Access Compliance Report

Public Rights-of-Way

Intersection ID: 5855	Main Street: W_SUGAR_CREEK_RD	Cross Street: NEVIN_RD	Location:	N
ADA ID: EDB0636EE624	Ramp Type: BlendTrans1	Initial Pass/Fail: Pass	Overall Compliance: No	Severity Score: 0

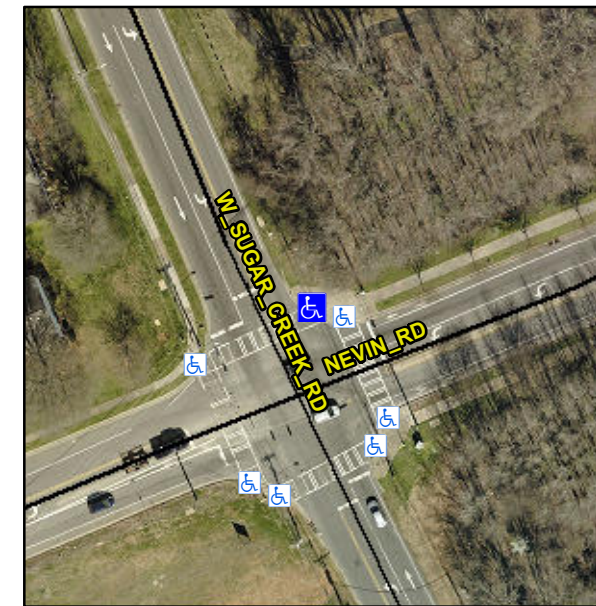
NO LNDG

Not Found, R304.2.1, R305.2

Remove & Replace Curb Ramp With Two New Directional Ramps or Equivalent.
